Request from HDR Land Development, LLC (purchaser) represented by Matt DeMey (agent) to rezone property located at 4680 NE 23 rd Avenue and approve a PUD Conceptual Plan. The subject property is owned by Richard N. Downs.			File # ZON2007-00035	
Description of Action	Rezone subject property from "A-1" Agricultural District to "PUD" Planned Unit Development and approve a PUD Conceptual Plan for "The Woods of Copper Creek" for approximately 71 acres for 60' wide lot single-family residential development, approximately 22 acres of 70' wide lot single-family development, and approximately 18 acres for medium-density multiple-family residential development to be defined with a future amendment.			
2020 Community Character Plan	Low-Density Residential and Not Designated.			
Horizon 2025 Transportation Plan	No Planned Improvements.			
Current Zoning District	"A-1" Agricultural District.			
Proposed Zoning District	"PUD" Planned Unit Development District.

HDR Land Development LLC - 4680 NE 23rd Avenue

ZON2007-00035

By same motion and vote, members recommended **APPROVAL** of a request to rezone property located at 4680 NE 23rd Avenue (Easton Blvd.) from "A-1" Agricultural District to "P

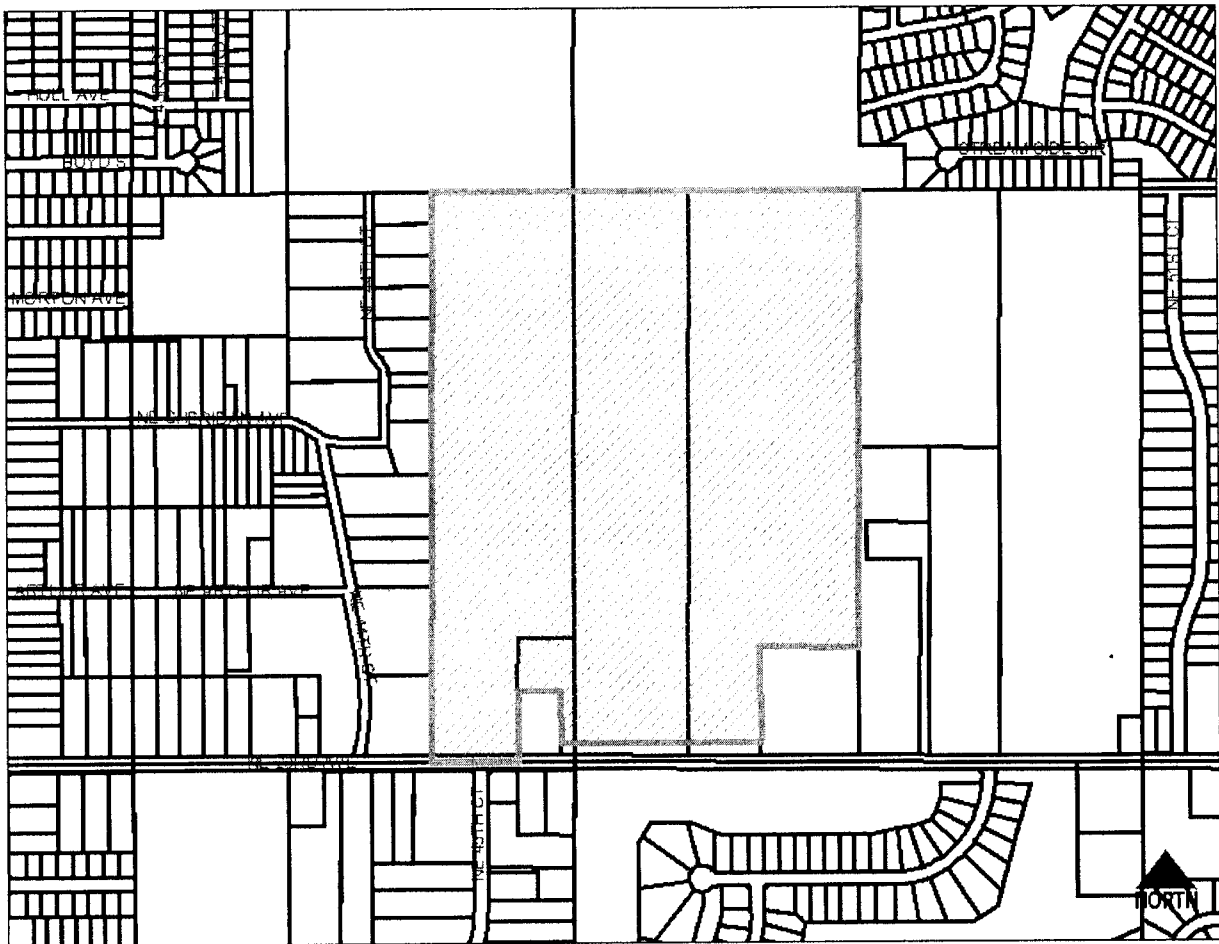
The PUD Conceptual Plan indicates that low-level shrubs and/or flower landscaping elements will be provided within all landscape islands within cul-de-sacs. These landscape areas would be planted by the developer and owned and maintained by a homeowners association. Staff recommends that this be revised to also include landscape islands within traffic circles.

The revised submittal responds to concerns raised by the Plan and Zoning Commission by shifting the westernmost north/south street 5' to the east in order provide additional lot depth to accommodate both tree preservation easements and bio-swaes at the rear of these lots.

The Traffic and Transportation Division has requested provision of a traffic circle in the north 4-way intersection of the eastern collector street. They have also indicated that the PUD Conceptual Plan must allocate half of the 80' ROW needed for NE 23rd Avenue and provide a 37' width pavement on the streets at NE 23rd to allow a 150' left-turn lane and taper back to 31' width.

- 10. **Architectural Guidelines:** The revised PUD Conceptual Plan submitted following the July 19, 2007 Planning Commission satisfies all of the conditions previously recommended in the Staff Report except for the requirement that dwellings have either architectural or cedar shingles.

The PUD Concept Plan proposes that roofing materials shall be asphalt-type shingles and that architectural shingles or cedar shakes are optional. The developer believes that as a trade-off for not requiring architectural shingles, they are 1) providing 19.4 acres of preservation easements, 2) exploring alternate setbacks from lot to lot where possible, and 3) exploring use of low impact design methods for stormwater management during the design and grading phases.

1. The roof on any home constructed shall be of architectural-type shingles or cedar shakes.
2. Provision of a traffic circle in the north 4-way intersection of the eastern collector street, with low-level shrubs and/or flower landscaping elements within the traffic circle that would be planted by the developer and owned and maintained by a homeowners association.
3. PUD Conceptual Plan must allocate half of the 80' ROW needed for NE 23rd Avenue (Easton Blvd.).
4. PUD Conceptual Plan must provide a 37' width pavement on the streets at NE 23rd Avenue (Easton Blvd.) to allow a 150' left-turn lane and taper back to 31' width.

1. The roof on any home constructed shall be of architectural-type shingles or cedar shakes.
2. Provision of a traffic circle in the north 4-way intersection of the eastern collector street, with low-level shrubs and/or flower landscaping elements within the traffic circle that would be planted by the developer and owned and maintained by a homeowners association.
3. PUD Conceptual Plan must allocate half of the 80' ROW needed for NE 23rd Avenue.
4. PUD Conceptual Plan must provide a 37' width pavement on the streets at NE 23rd to allow a 150' left-turn lane and taper back to 31' width.
